**TYRONE TOWNSHIP PLANNING COMMISSION  
REGULAR MEETING AGENDA  
March 8, 2022 7:00 p.m.**

# Special Land Use and Combined Preliminary and Final Site Plan Review for Tyrone Township, Michigan

**Applicant:** Brendan and Stephanie Foster  
**Owner:** Benecor INC  
**Request:** Special land use and combined preliminary and final site plan for a mini-warehouse facility  
**Plan Date:** January 17, 2022 (*site plan*)  
May 4, 2021 (*building plan*)  
**Use Statement Date:** undated

1 FLOOR PLAN  
PRI 1/8" = 1'-0"

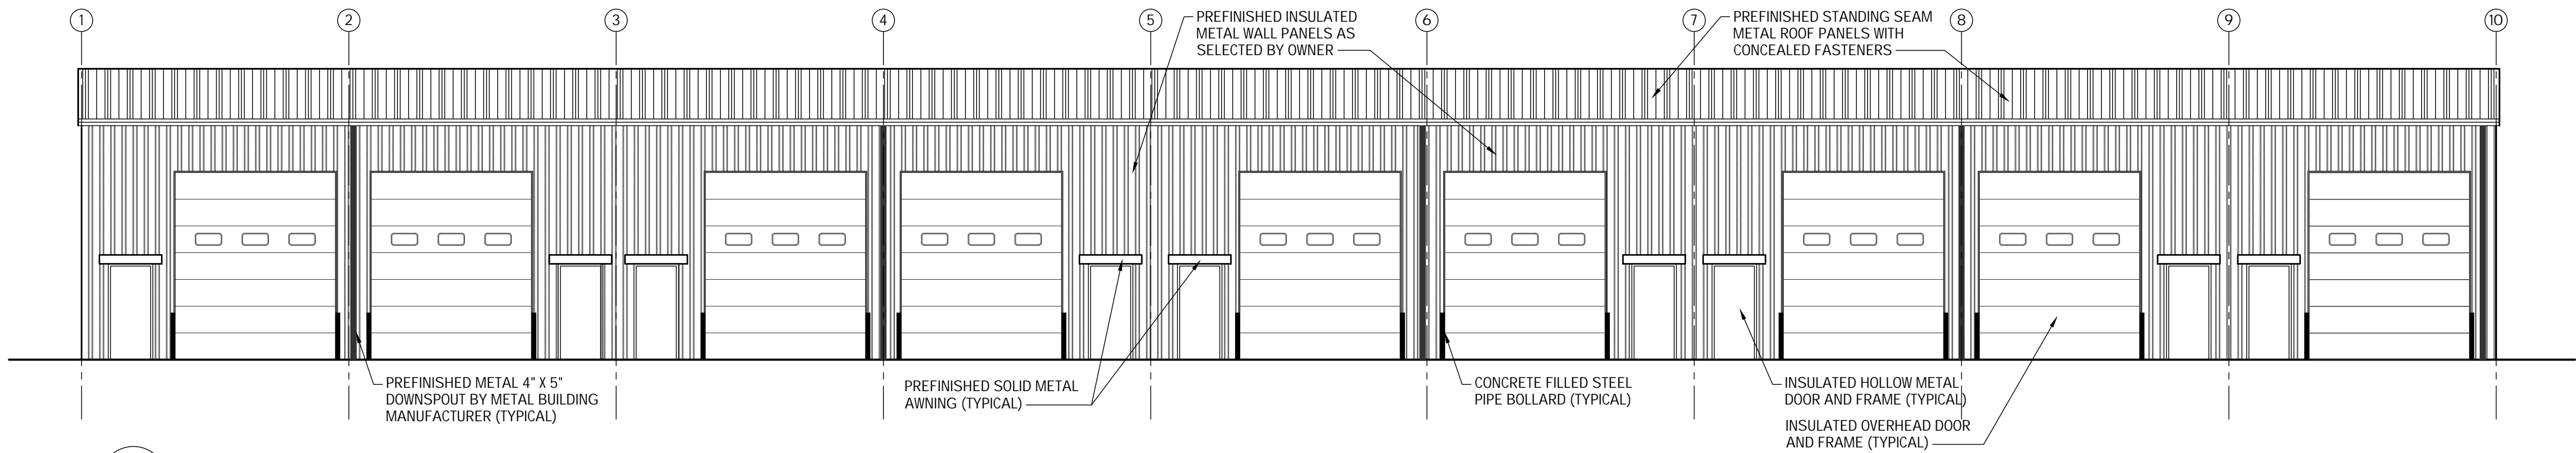
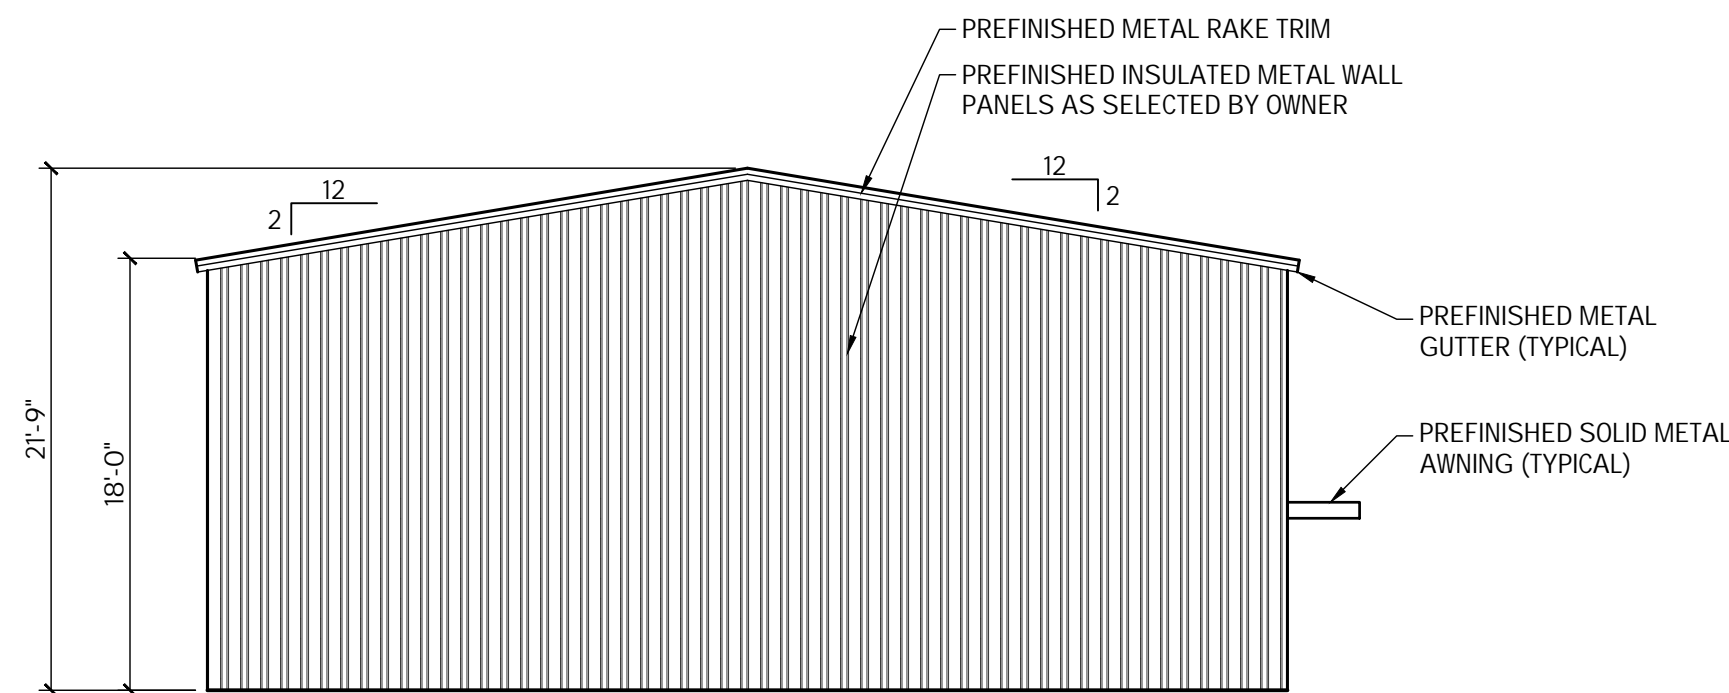
The building plans do not show light fixtures on the façade. Wall-mounted lighting can cause glare when the wall directly below the fixture is a light color.

**Items to be Addressed:** 1) Specifications for the light fixtures shall be added to the site plan. 2) Typical fixture location and details, including height and any treatment to reduce glare from the wall, should be added to the building plans.

***Comments:*** *Sheet PR1 indicates the exterior walls will be prefinished insulated panels, as selected by the owner; the roof will be standing seam metal roof panels; and the bay doors will be insulated overhead doors.*

C200

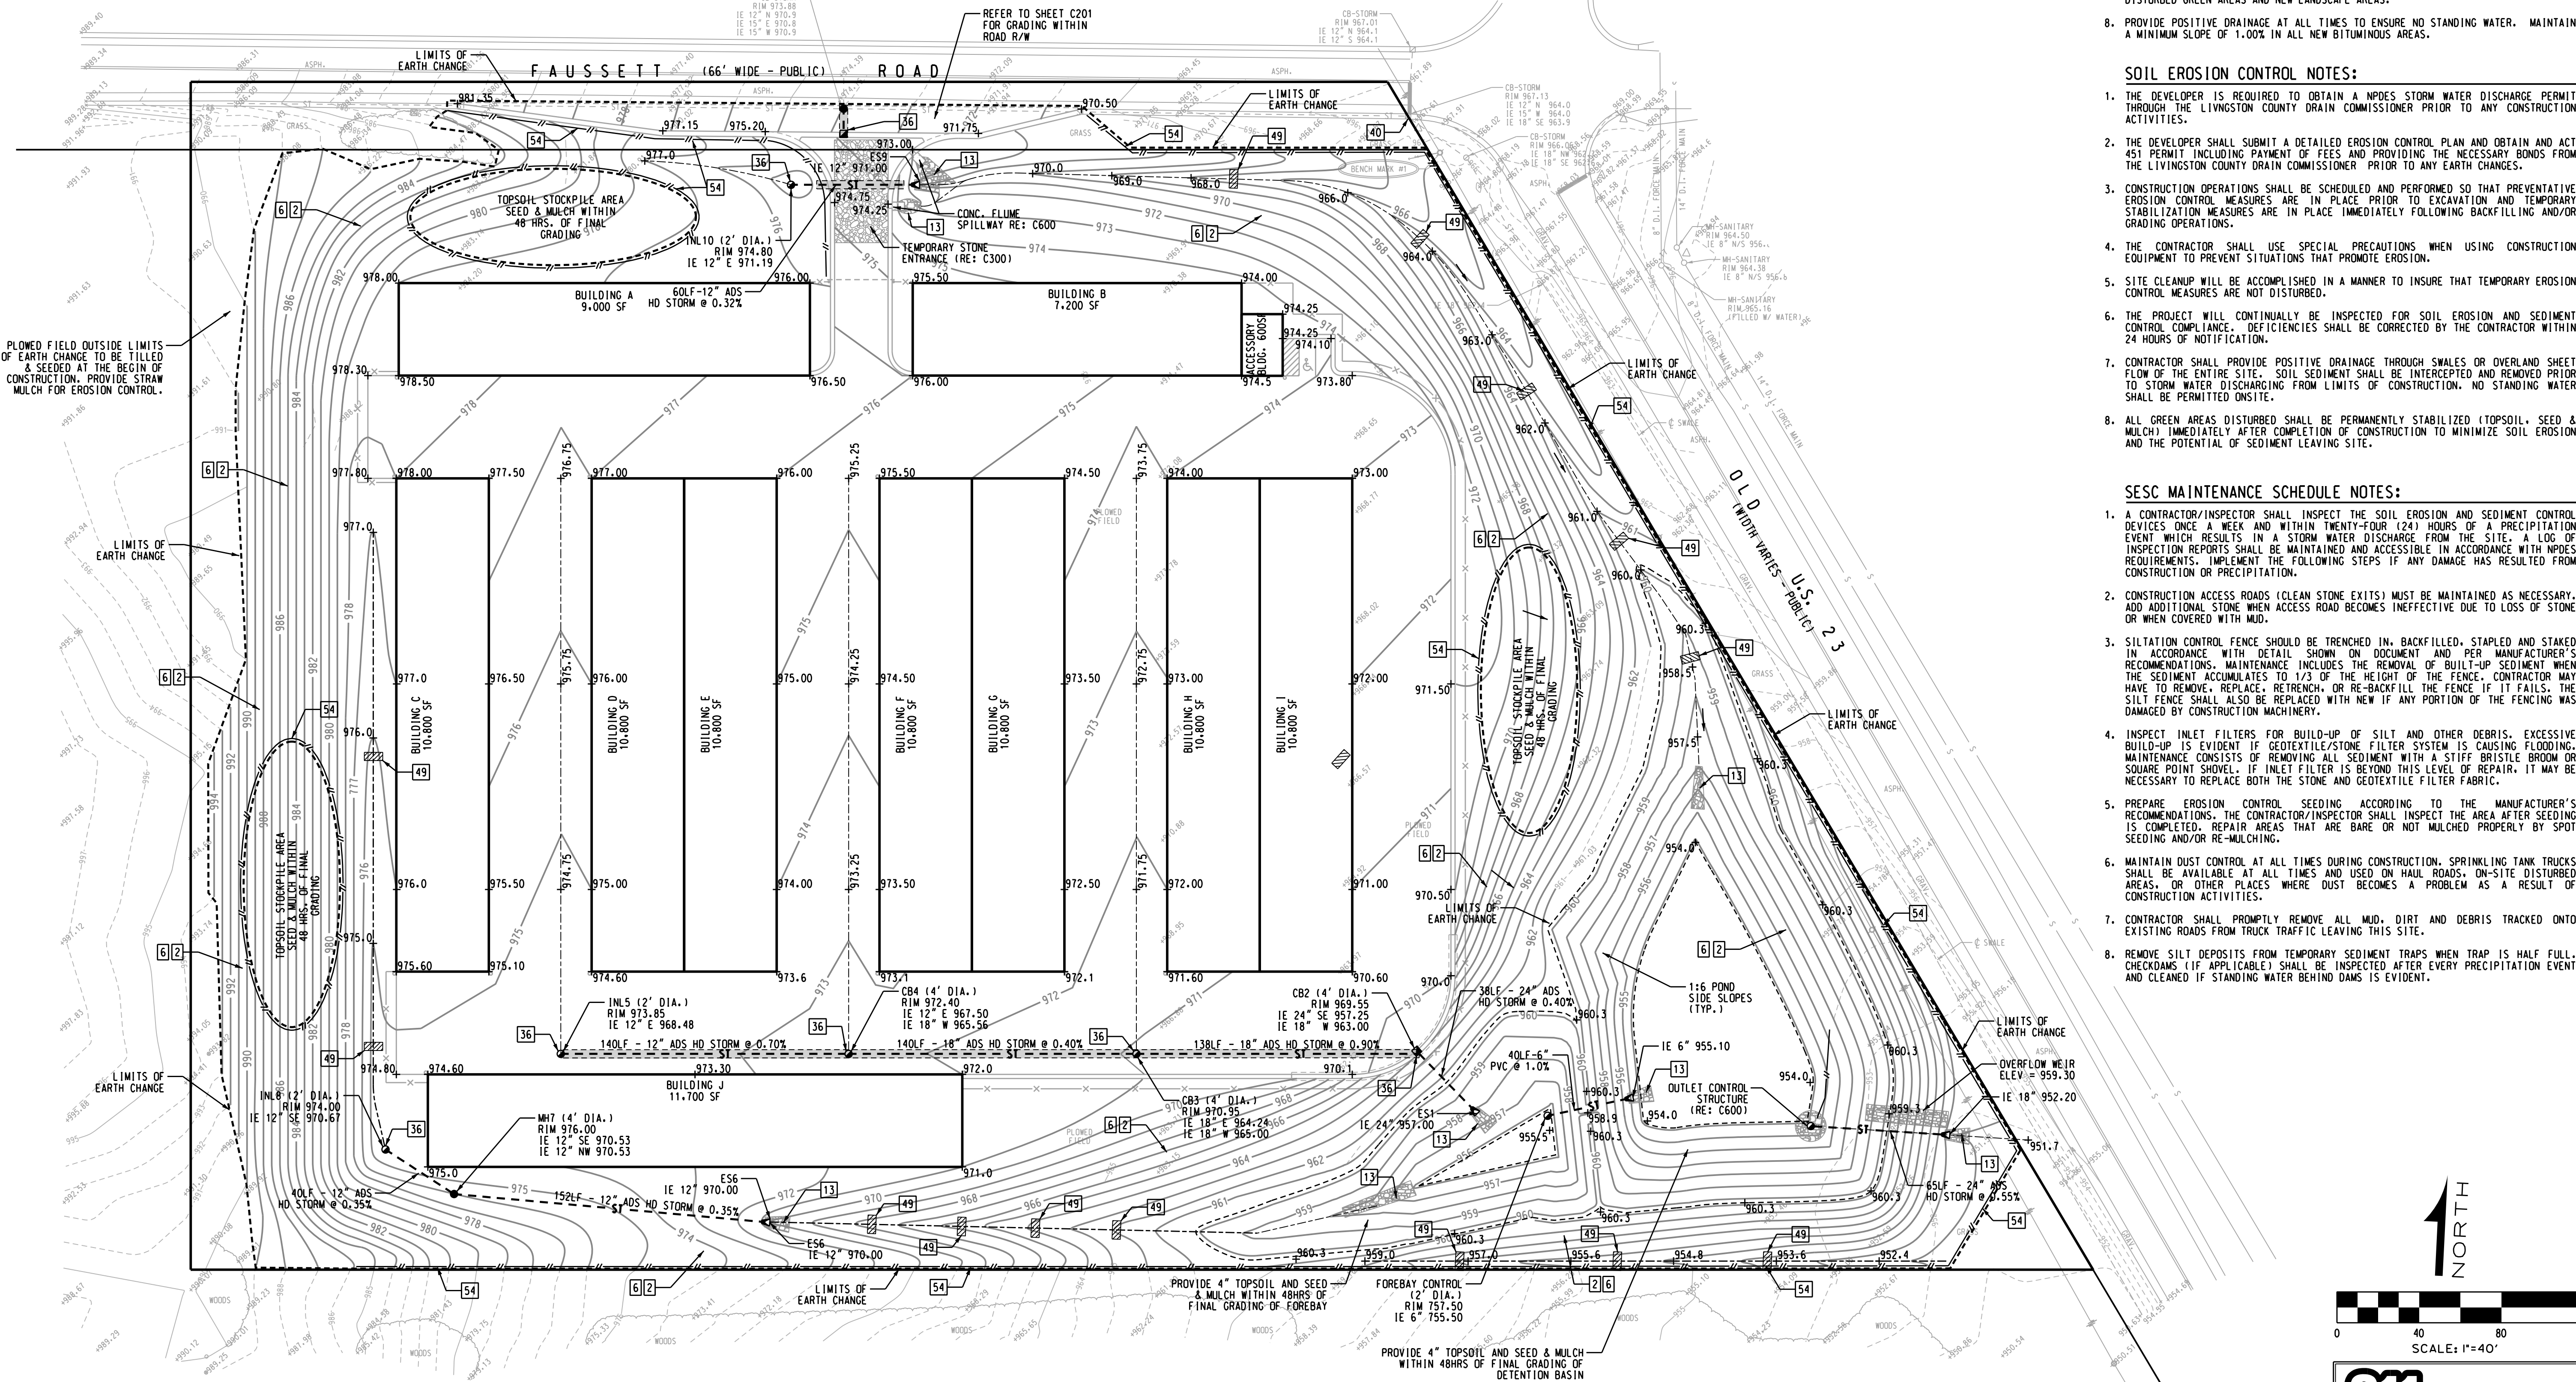
The location for a proposed monument sign to the west of the entrance driveway is shown on Sheet C200. Additional information, such as height, sign area, or materials, are not included.

It is not possible to determine compliance with other sign standards based on the information provided at this time. The site plan notes that the sign will be under a separate permit.

**Items to be Addressed:** 1) Clear-vision zones shall be added to the site plan, as noted in §27.06(D). 2) Sign shall be relocated, if necessary, with setbacks dimensioned.

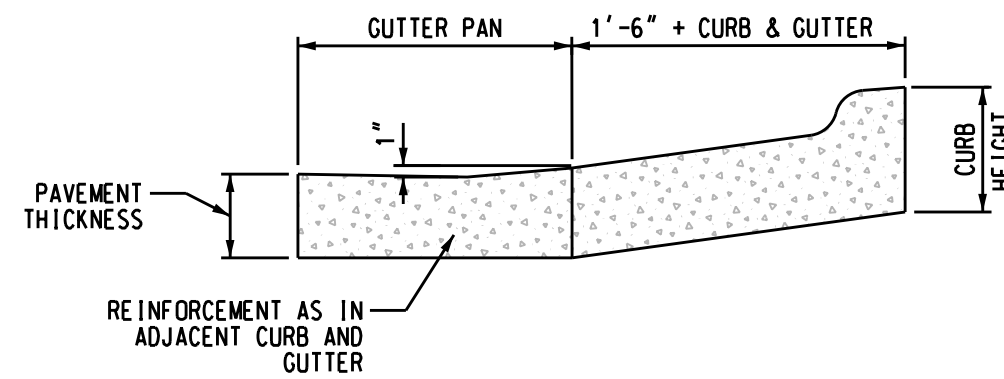
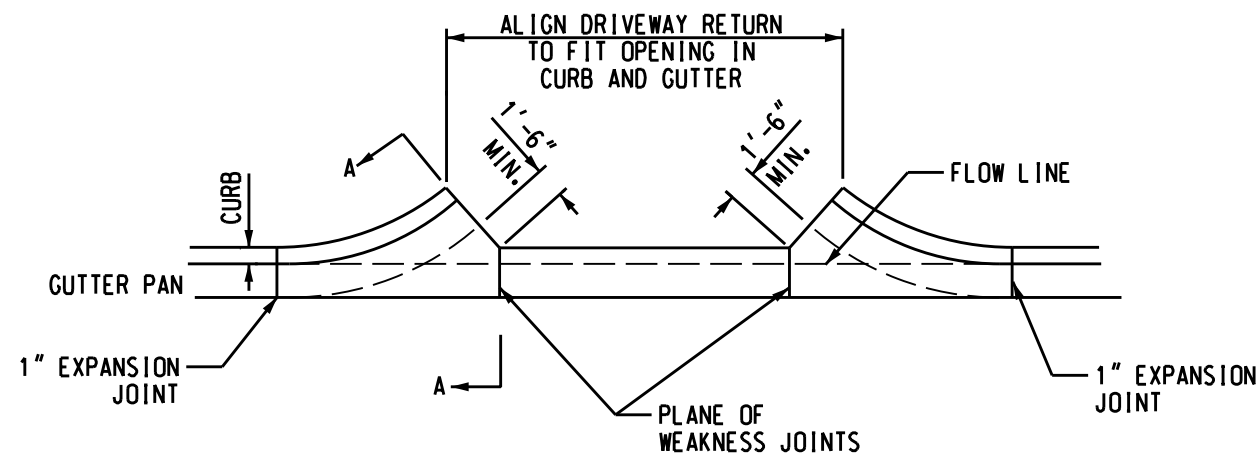
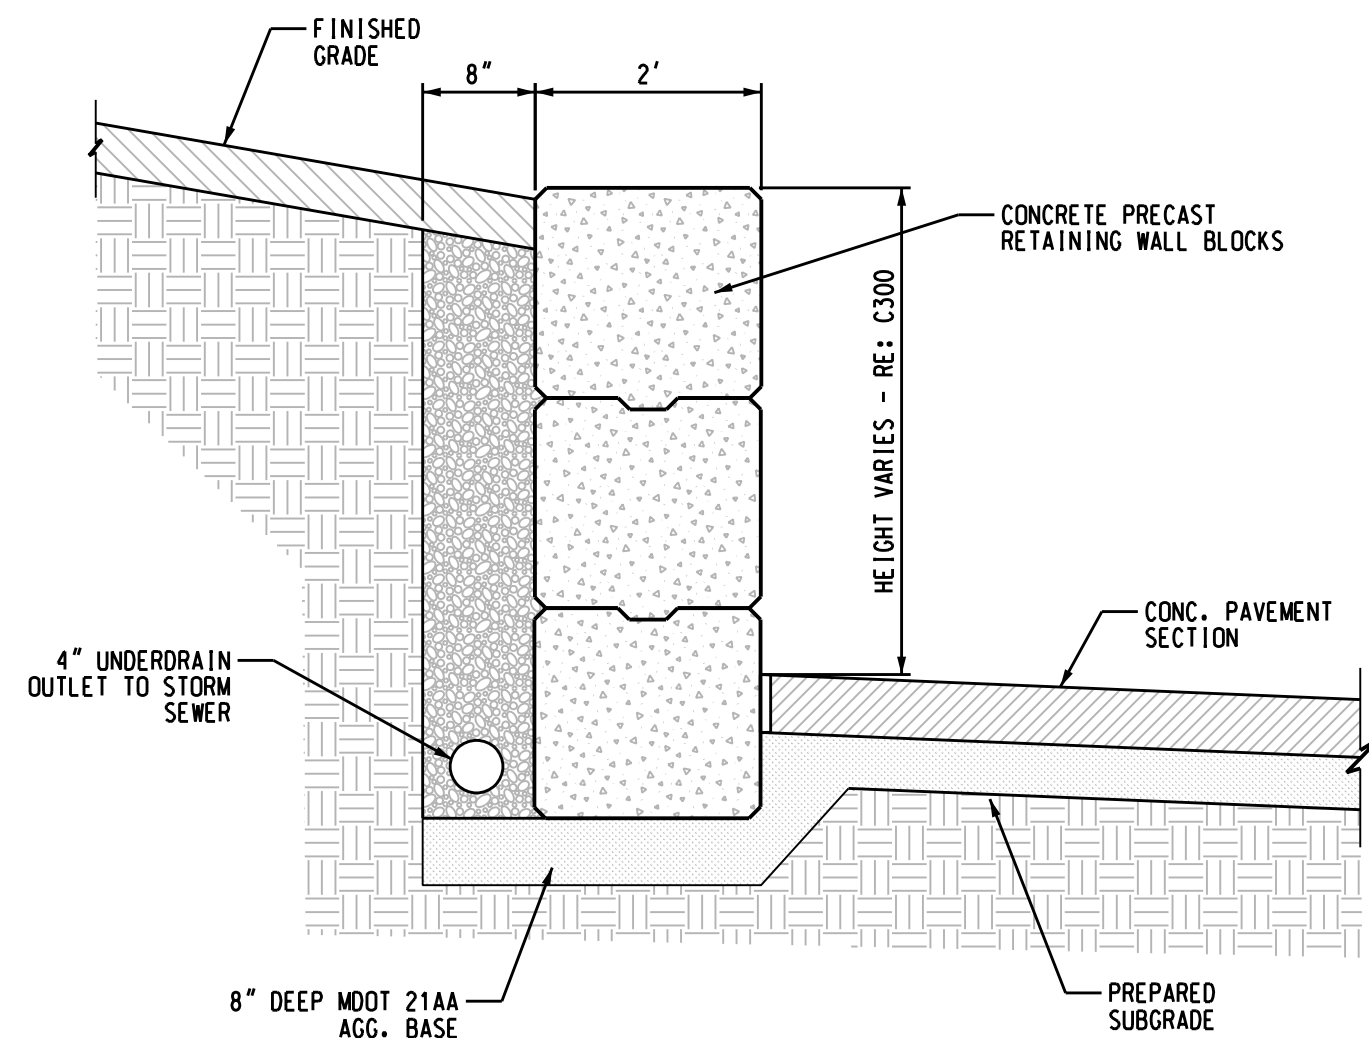
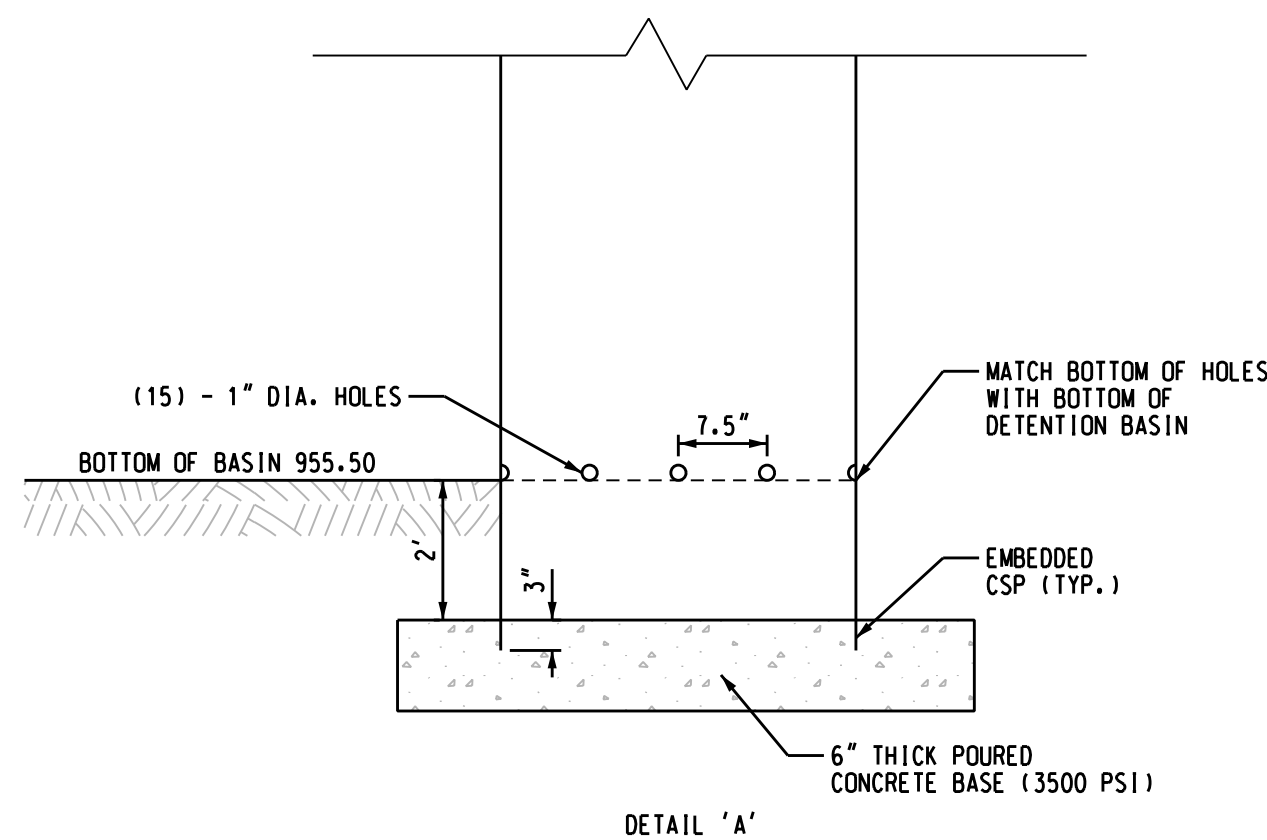
A landscape plan is included on Sheet C500. It shows the location of proposed landscaping along the boundaries of and within the site and includes a planting list and landscaping calculations.

The proposed landscaping appears to be consistent with the Zoning Ordinance standards. It includes a variety of plantings intended to screen the mini-warehouse facility. The Planning Commission should consider if the significant change in elevation from the developed area to Old US-23 warrants additional landscaping to provide the desired screening.

The landscaping plan does not appear to include any irrigation system.

***Items to be Addressed:*** 1) Planning Commission consideration if additional landscaping is necessary along Old US-23. 2) Irrigation system should be added to the site plan.
